Access Audit Site Report

Enchanted Rock State Natural Area

Accessibility Evaluation

Inspection Date: 09/28/2022

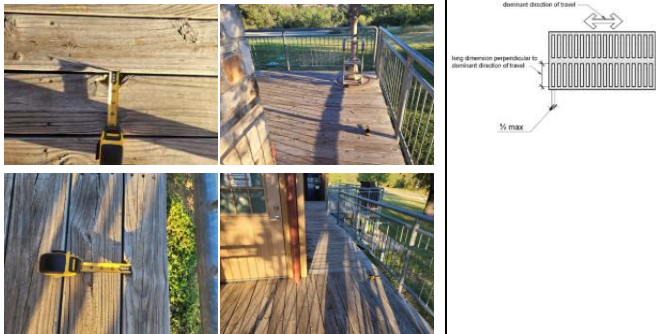
<small>Source: ADAAG, 2010. For each 100 ft horizontal distance, one 100 ft stall and one 50 ft stall.</small>	Total Number of Parking Spaces	Minimum Number of Required Accessible Parking Spaces	20	3	21 to 25	5	26 to 30	6	31 to 35	7	36 to 40	8	41 to 45	9	46 to 50	10	51 to 55	11	56 to 60	12	61 to 65	13	66 to 70	14	71 to 75	15	76 to 80	16	81 to 85	17	86 to 90	18	91 to 95	19	96 to 100	20
Total Number of Parking Spaces	Minimum Number of Required Accessible Parking Spaces																																											
20	3																																											
21 to 25	5																																											
26 to 30	6																																											
31 to 35	7																																											
36 to 40	8																																											
41 to 45	9																																											
46 to 50	10																																											
51 to 55	11																																											
56 to 60	12																																											
61 to 65	13																																											
66 to 70	14																																											
71 to 75	15																																											
76 to 80	16																																											
81 to 85	17																																											
86 to 90	18																																											
91 to 95	19																																											
96 to 100	20																																											
4	Headquarters Area: HQ - Parking	[30.496025, -98.819779 2]	The cross slopes (narrow dimension) and/or running slopes (long dimension) of the access aisle exceeds 2%. The running slope and the cross slope in an accessible parking stall and the access aisle must not exceed 2%.	Stall - 4.5%	Repair or correct slope of parking space and access aisle to max 2.08% in any direction.	2015 ABAAS Section: 502.4 2012 TAS Section: 502.4 2010 ADAS Section: 502.4

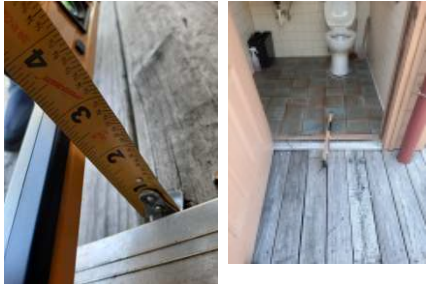
Finding Number	Area Description	Lat/Long	Finding	As Built	Recommendation	Citation	Photos	Figure
35	Headquarters Area: HQ - Employee Spaces	[30.49603, -98.82]	An item or items project more than 4 inches into the circulation path. Wall-mounted objects that have leading edges between 27 inches and 80 inches from the floor must not project more than 4 inches into the circulation path. Protruding objects that extend to the floor or within 27 inches of the floor are cane detectable and are therefore not hazardous. Where it is necessary or desirable to have objects protrude from the wall, a manner of cane detection must be provided.	Storage shelves protrude 13"	Relocate protruding objects or place cane detectable warning or bollard at foot of item.	2015 ABAAS Section: 307.2 2012 TAS Section: 307.2 2010 ADAS Section: 307.2

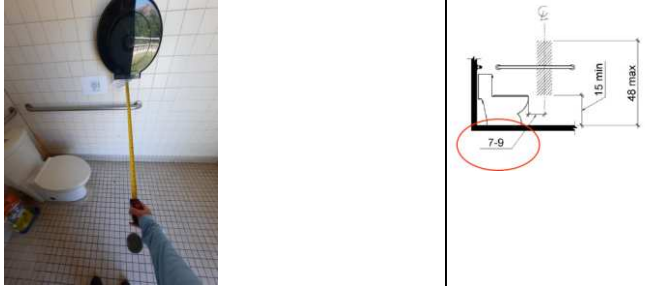
68	Headquarters Area: HQ - Women's Restroom	[30.4960864 , -98.820020 6]	The self closing faucet controls do not stay open for a minimum of 10 seconds. Faucet controls and operating mechanisms shall be operable with one hand and shall not require tight grasping, pinching or twisting of the wrist. The force required to activate controls shall be no greater than 5 lb. Lever-operated, push-type and electronically controlled mechanisms are examples of acceptable designs. Self-closing valves are allowed if the faucet remains open for at least 10 seconds.	HQ women's restroom (near stairs) - Sink pipes disconnected, unable to test	Water shut off - unable to test. Ensure sink faucets remain on for min. 10 seconds when reopened.	2015 ABAAS Section: 606.4 2012 TAS Section: 606.4 2010 ADAS Section: 606.4

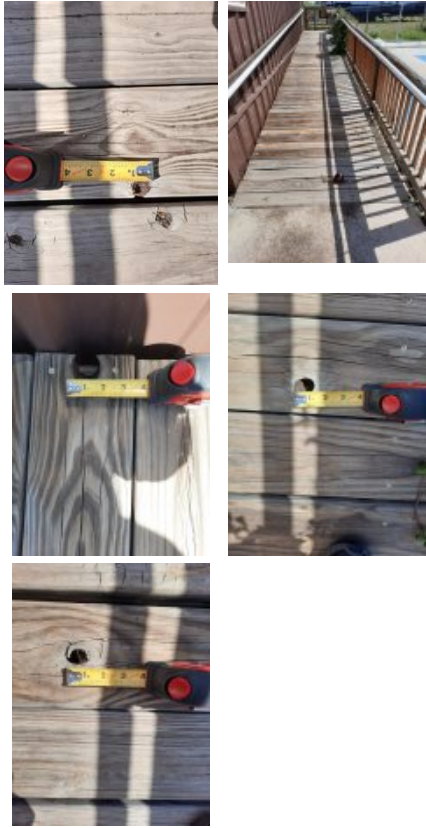
87	Headquarters Area: HQ - Women's Restroom	[30.4960917, -98.8199783]	The grab bar height and/or spacing fails. Grab bars must be mounted between 33" and 36" to the top of the gripping surface. There must be 1.5" of clearance between the grab bar and the wall. There must be a minimum of 1.5" of clearance below and minimum 12" above the grab bar to any dispenser or other obstruction.	HQ women's restroom (near utility closet) - TP dispenser is 9.5" above bar	Remount toilet paper dispenser max 7" to 9" from front of toilet, 15" to 48" above the finished floor (AFF) and min 12" above or 1.5" below grab bar.	2015 ABAAS Section: 609.3, 609.4 2012 TAS Section: 609.4, 609.3 2010 ADAS Section: 609.3, 609.4

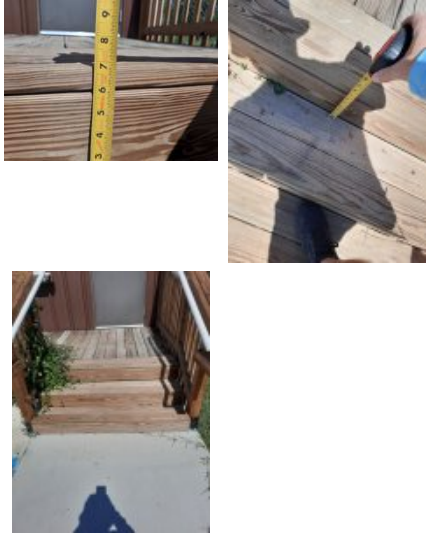
90	Headquarters Area: HQ - Women's Restroom	[30.4960917 , -98.819974 3]	The accessible route contains running slopes greater than 5 percent and cross slopes greater than 2 percent across the width of the walk and has not been constructed as a ramp (i.e. handrails, wheel guides, etc.). When the slope in the direction of travel of any walk exceeds 1 unit vertical in 20 units horizontal (5-percent slope), it must be constructed as ramp. Surface cross slopes must not exceed one unit vertical in 48 units. Horizontal (2-percent slope).	HQ women's restroom (near utility closet) - 3.2% slope near door	Correct or repair slope to max 2.08% in restroom.	2015 ABAAS Section: 403.3 2012 TAS Section: 403.3 2010 ADAS Section: 403.3

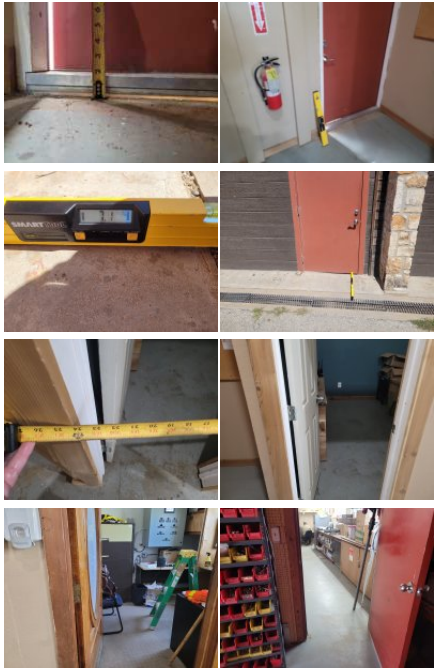
101	Employee Areas: Maintenance	[30.4941415 , -98.8211617]	The top rim of the sink is too high. All lavatories/sinks that are designated to be accessible shall be a minimum 17 inches in horizontal depth and mounted with the rim or counter edge no higher than 34 inches above the finished floor. Knee and toe clearance has not been provided at the sink. The knee clearance shall be 11 inches deep minimum at 9 inches above the finish floor or ground, and 8 inches deep minimum at 27 inches above the finish floor or ground. The toe clearance is the space under the sink between the finish floor or ground and 9 inches above the finish floor 30 inches wide minimum.	Break room/laundry - sink rim at 36.25"; lacks knee clearance	Lower sinks to max 34" above the finished floor (AFF) to front of rim. Remove under sink cabinets to provide knee and toe clearances under sinks and insulate exposed pipes	2015 ABAAS Section: 606.3 2012 TAS Section: 606.3 2010 ADAS Section: 606.3

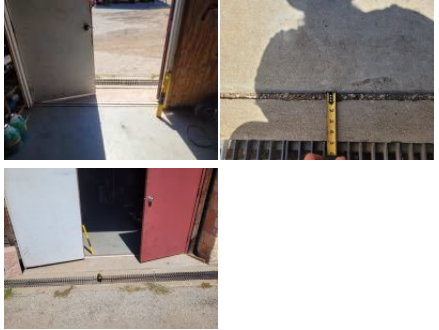
Finding Number	Area Description	Lat/Long	Finding	As Built	Recommendation	Citation	Photos	Figure
102	Employee Areas: Maintenance	[30.4941545, -98.8211688]	The controls are located such that operation require reaching across burners. Where knee and toe space is provided, the underside of the range or cooktop shall be insulated or otherwise configured to prevent burns, abrasions, or electrical shock. The location of controls shall not require reaching across burners	Break room/laundry - oven controls on back, require reach across burners	Replace oven with one having controls on the front panel.	2015 ABAAS Section: 804.6.4 2012 TAS Section: 804.6.4 2010 ADAS Section: 804.6.4		
103	Employee Areas: Maintenance	[30.494128, -98.8211715]	Minimum maneuvering clearances at doors and gates shall comply with 404.2.4. Maneuvering clearances shall extend the full width of the doorway and the required latch side or hinge side clearance. Door openings shall provide a clear width of 32 inches (815 mm) minimum. Clear openings of doorways with swinging doors shall be measured between the face of the door and the stop, with the door open 90 degrees. Openings more than 24 inches (610 mm) deep shall provide a clear opening of 36 inches (915 mm) minimum. There shall be no projections into the required clear opening width lower than 34 inches (865 mm) above the finish floor or ground. Projections into the clear opening width between 34 inches (865 mm) and 80 inches (2030 mm) above the finish floor or ground shall not exceed 4 inches (100 mm). Hand-activated door opening hardware, handles, pulls, latches, locks, and other operating devices on accessible doors shall have a shape that is easy to grasp with one hand and does not require tight grasping, tight pinching or twisting of the wrist to operate. Hardware shall be 34 inches minimum and 48 inches maximum above the finish floor or ground.	Maintenance employee restroom door - wall and toilet back in pull side clearance, knob, 29" wide	For all doors along the public circulation route, provide required maneuvering clearance on push and pull side of doors. For all doors along the public circulation route, replace doors with doors having 80" overhead clearance and 32" clear width. For all doors along the public circulation route, replace hardware with lever hardware or hardware operable without a tight pinch or grasp.	2010 ADAS Section: 404.2.3, 404.2.7, 404.2.4, 404.2.11, 404.2.11 Exception

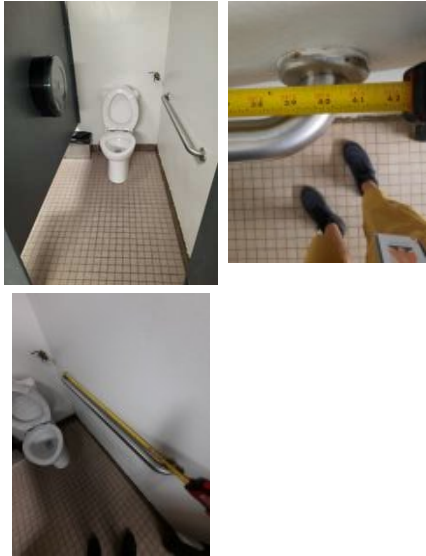
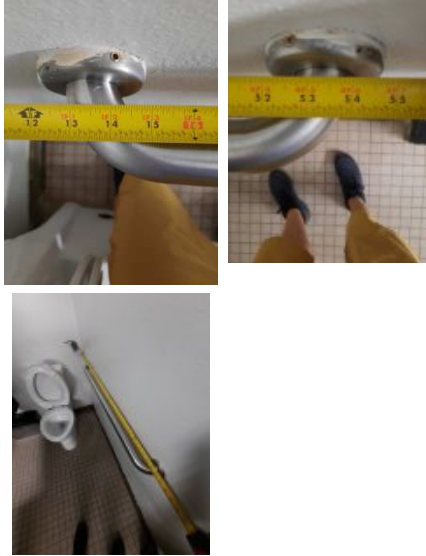
Finding Number	Area Description	Lat/Long	Finding	As Built	Recommendation	Citation	Photos	Figure
166	Walk-In Campsites: Walk-In - Women's Restroom	[30.4967033 , -98.8230001]	The mirror is mounted too high. Mirrors not located above lavatories or countertops shall be installed with the bottom edge of the reflecting surface 35 inches maximum above the finish floor or ground.	49" to bottom of mirror not above the lavatory	Lower mirror not over a sink or counter to max 35" AFF to the bottom reflective surface and 74" to the top.	2015 ABAAS Section: 603.3 2012 TAS Section: 603.3 2010 ADAS Section: 603.3		
167	Walk-In Campsites: Walk-In - Women's Restroom	[30.4966871 , -98.8229974]	Knee clearance at 27 inches off the floor is not 8 inches minimum deep. The knee clearance, measured from the bottom of the apron or the outside bottom edge of the lavatory, must be 27 inches at a point located 8 inches back from the front edge and continuing to 11 inches minimum in depth at 9 inches above the floor. The top of the lavatory rim may be no higher than 34 inches.	Sinks lack knee clearance - 19.75" to boards	Remove boards to provide knee and toe clearances under sinks	2015 ABAAS Section: 306.3.1, 306.3.2, 306.3.3, 306.3.4 , 306.3.5 2012 TAS Section: 306.3.2, 306.3.3, 306.3.4, 306.3.5, 306.3.1 2010 ADAS Section: 306.3.3, 306.3.2, 306.3.4, 306.3.5, 306.3.1

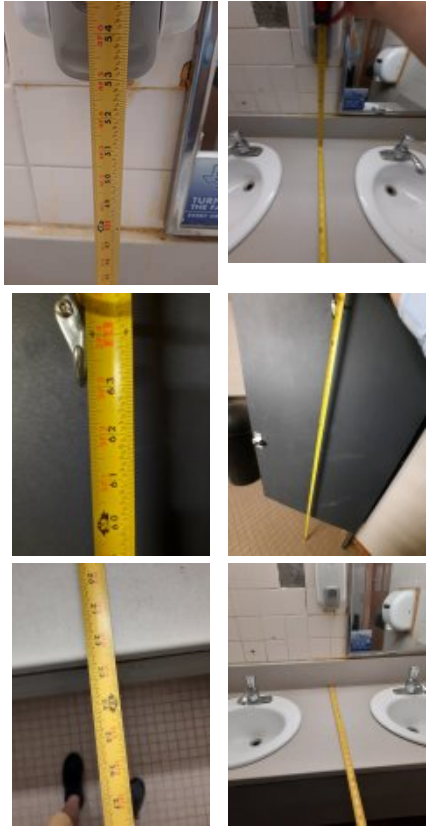
220	Trails: Trails - Gazebo Men's Restroom	[30.4980745 , -98.818707 6]	Minimum maneuvering clearances at doors and gates shall comply with 404.2.4. Maneuvering clearances shall extend the full width of the doorway and the required latch side or hinge side clearance. Maneuvering clearances shall have a max slope of 2.08%. The threshold at a doorway shall be no higher than 1/2 inch. Changes in level between 1/4 inch and 1/2 inch must be beveled at 1:2 or less. 1/4 inch is the maximum vertical rise. Exterior doors are recommended to be maintained at 8.5 lbf as a smart practice. Force is to be measured at the operating hardware or 30 inches from the hinges, whichever is greater.	Summit Trail/Gazebo men's restroom door - slope of 3% in pull side clearance, threshold with .5" CIL on pull side, 13# push	For all doors along the public circulation route, provide required maneuvering clearance on push and pull side of doors. For all doors along the public circulation route, correct slope in door clearance to max 2.08%. For all doors along the public circulation route, provide beveled threshold. For all doors along the public circulation route, inspect, adjust, and maintain 8.5 lbf to open exterior doors as a smart practice.	2010 ADAS Section: 404.2.3, 404.2.7, 404.2.4, 404.2.11, 404.2.11 Exception

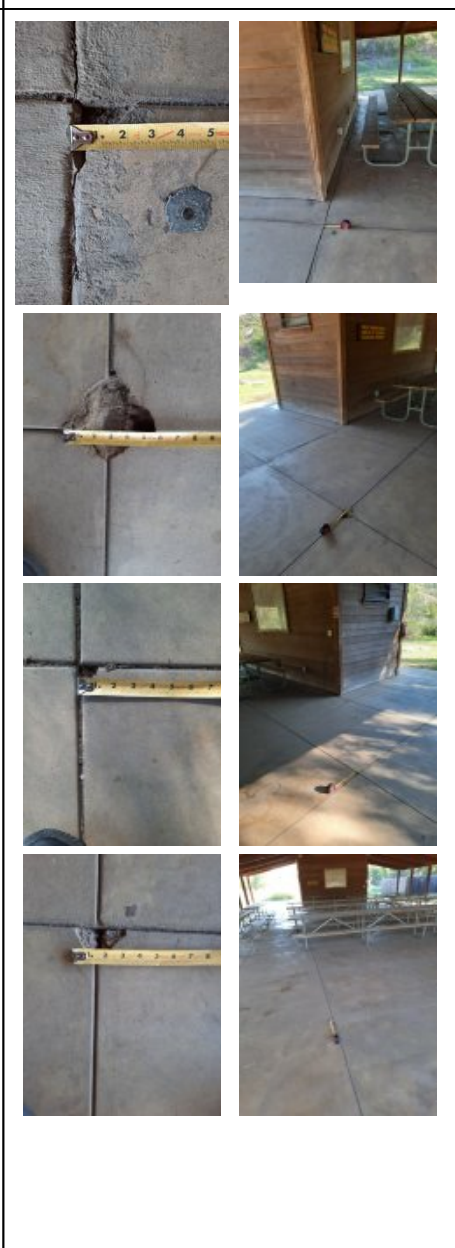
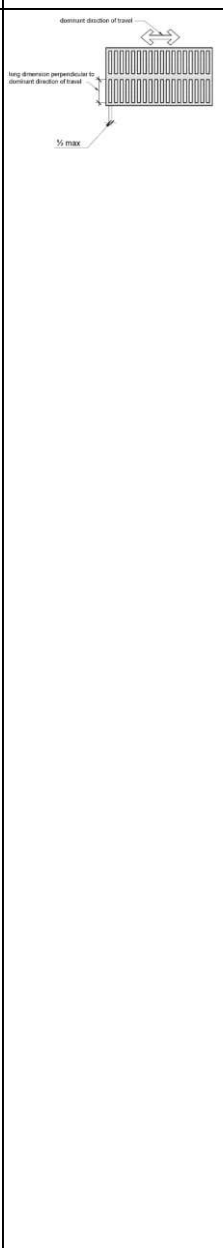
268	Trails: Trails - Picnic Areas	[30.49739, -98.81794]	Water spouts at water hydrants and water utility hook-ups shall be 28 inches (710 mm) minimum and 36 inches (915 mm) maximum above the ground. An accessible access route is not provided between elements, spaces and the facilities provided within the accessible camping unit. At least one outdoor recreation access route shall connect accessible elements, spaces and facilities provided within camping units with mobility features.	Water spout low, lacks AR (seems to not be in use at this time)	Remount water spouts to 28" min or 36" max above the ground as a smart practice. Create AR with crushed and compacted stone or similar outdoor material to camp sites and one of each type of amenity.	2015 ABAAS Section: 1011.6		
269	Trails: Trails - Interpretive Loop	[30.49798, -98.82065]	The operable part is not accessible because there is not adequate clear floor space for either a forward or side approach. The clear floor or ground space shall be 30 inches minimum by 48 inches minimum. Water spouts at water hydrants and water utility hook-ups shall be 28 inches (710 mm) minimum and 36 inches (915 mm) maximum above the ground.	Dirt and crushed stone surface at trail map and water spout, water spout low	Provide required 30" by 48" CFS at operable parts. Remount water spouts to 28" min or 36" max above the ground as a smart practice.	2015 ABAAS Section: 305.3 2012 TAS Section: 305.3 2010 ADAS Section: 305.3
